PCI-SIG ENGINEERING CHANGE NOTICE

TITLE:	ID-Based Ordering
DATE:	January 16, 2008, updated 29 May 2008
AFFECTED DOCUMENTS:	PCI Express Base Specification version 2.0 Errata to 2.0 Base Spec Section 2.4.1
SPONSORS:	Intel, Advanced Micro Devices, Hewlett-Packard, IBM

Figure 2-12: Attributes Field of Transaction Descriptor

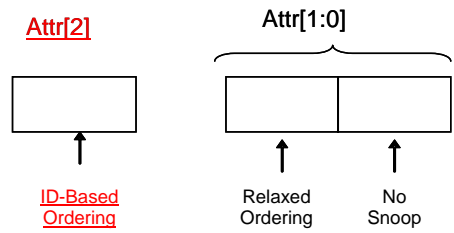
Modify Section 2.2.6.3 as shown:

Note that attributes are hints that allow for optimizations in the handling of traffic. Level of support is dependent on target applications of particular PCI Express peripherals and platform building blocks. Refer to PCI-X 2.0 for additional details regarding these attributes. Note that attribute bit 2 is not adjacent to bits 1 and 0 (see figure 2-13 and 2-14).

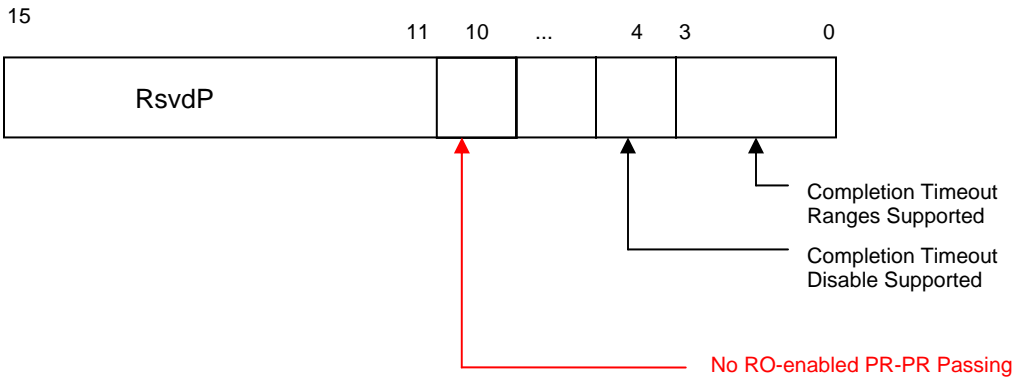
The Requester of an MSI/MSI-X transaction must set the No Snoop and Relaxed Ordering attributes of the Transaction Descriptor to 0b. A Requester of an MSI/MSI-X transaction is permitted to set the ID-Based Ordering (IDO) attribute if use of the IDO attribute is enabled.

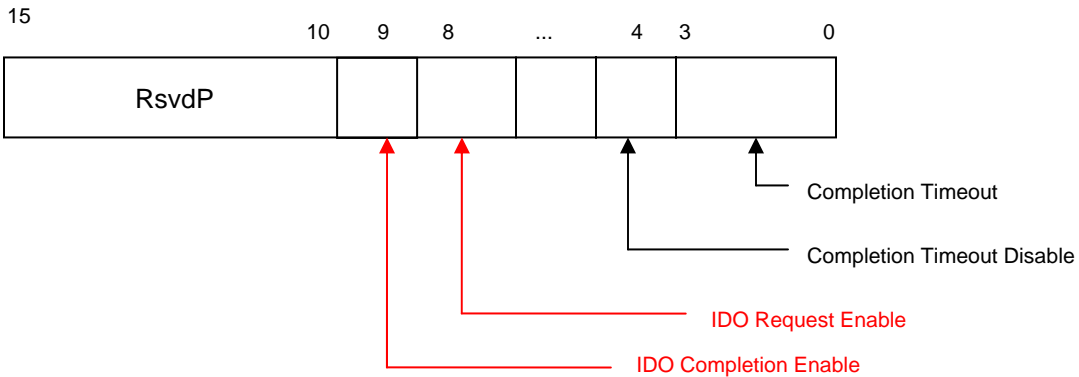
...		
10	<p>No RO-enabled PR-PR Passing – If this bit is Set, the routing element never carries out the passing permitted by Table 2-24 entry A2b that's associated with the Relaxed Ordering Attribute field being Set.</p> <p>This bit applies only for Switches and RCs that support peer to peer traffic between Root Ports. This bit applies only to Posted Requests being forwarded through the Switch or RC and does not apply to traffic originating or terminating within the Switch or RC itself. All ports on a Switch or RC must report the same value for this bit.</p> <p>For all other functions, this bit must be 0b.</p>	Hwlnit

Figure E-1: Reference Topology for IDO Use

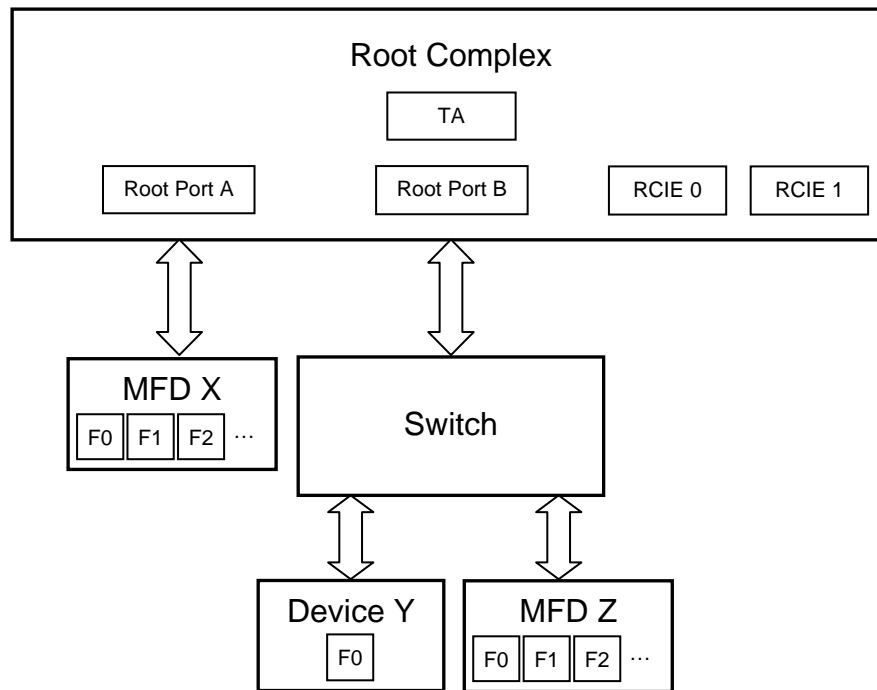
Figure E-1 shows a reference topology. The reference topology is not intended to discourage the use of IDO with other topologies, but rather to provide specific examples for discussion.

Here are some examples in the context of traffic between MFD X and the RC in Figure E-1.

Here are some examples in the context of traffic within the Switch in Figure E-1.

Here are some examples for the Root Complex Integrated Endpoints (RCIEs) in Figure E-1. The benefits are basically the same as for the MFD/RP Direct Connect case.

For example, in Figure E-1 if Device Y and MFD Z are communicating with P2P traffic and also communicating via host memory, it is not always safe for them to Set IDO in the TLPs they originate. As an example failure case, let’s assume that Device Y does a DMAW (to host memory) followed by a P2P Write to MFD Z. Upon observing the P2P Write, let’s assume that MFD Z then does a DMAW to the same location earlier targeted by the DMAW from Device Y. Normal ordering rules would guarantee that the DMAW from Device Y would be observed by host memory before the DMAW from MFD Z. However, if IDO is set in the DMAW from MFD Z, the RC

As an example, in Figure E-1 if Device Y and MFD Z are communicating with P2P traffic and also communicating with host software, it is not always safe for Root Port B to Set IDO in the TLPs it originates. For example, let's assume that Device Y does a P2P Write to MFD Z followed by a DMAW (to host memory). Upon observing the DMAW, let's assume that the host does a PIOW to MFD Z. Normal ordering rules would guarantee that the P2P Write from Device Y would be observed by MFD Z before the PIOW from the host. However, if IDO is set in the PIOW from the host, the Switch would be permitted to have the PIOW pass the P2P Write, ultimately having the two Writes arrive at MFD Z out of order.
